**PARTS & SERVICE DEPARTMENT**

**Bulletin Number:** 2008-111

**SUBJECT:** Energy-Rite Pool Heater Igniter Gasket Change

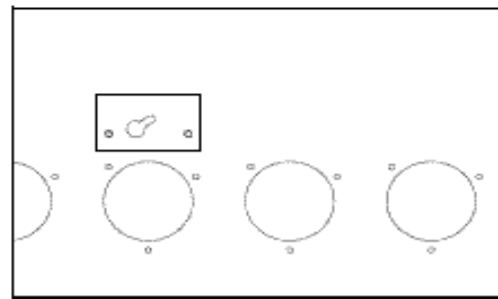
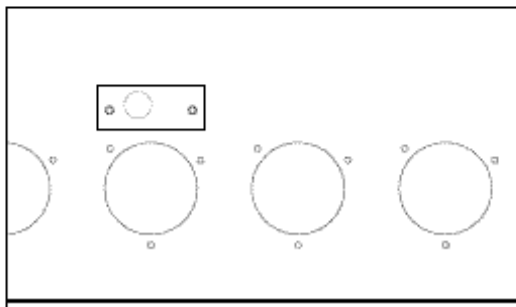
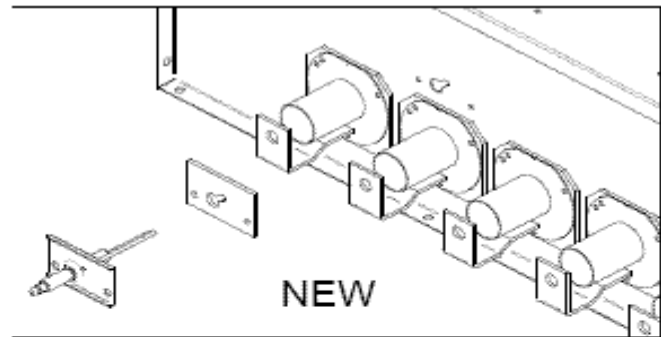
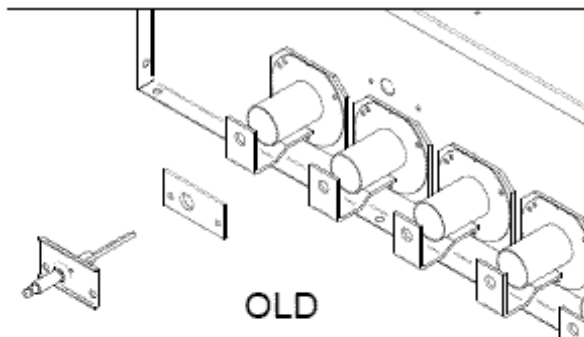
The Energy-Rite Pool Heaters consisting of models ER (N, L) 152, 202, 252, 302 and 402 are now manufactured with a smaller igniter opening and larger igniter gasket. This slight change was instituted to reduce the potential for combustion air from the front chamber pushing through the igniter opening. This excess air blowing across the igniter could possibly contribute to hard starts in some units.

The images below indicate the updated igniter gasket and sheet metal.

Starting date of 8-22-08 for the new sheet metal door (H08H00010934 for non-ASME) and (H08H00211537 for ASME)

Starting date of 9-18-08 for the new gasket (I08H00011037 for non-ASME) and (I08H00212501 for ASME)
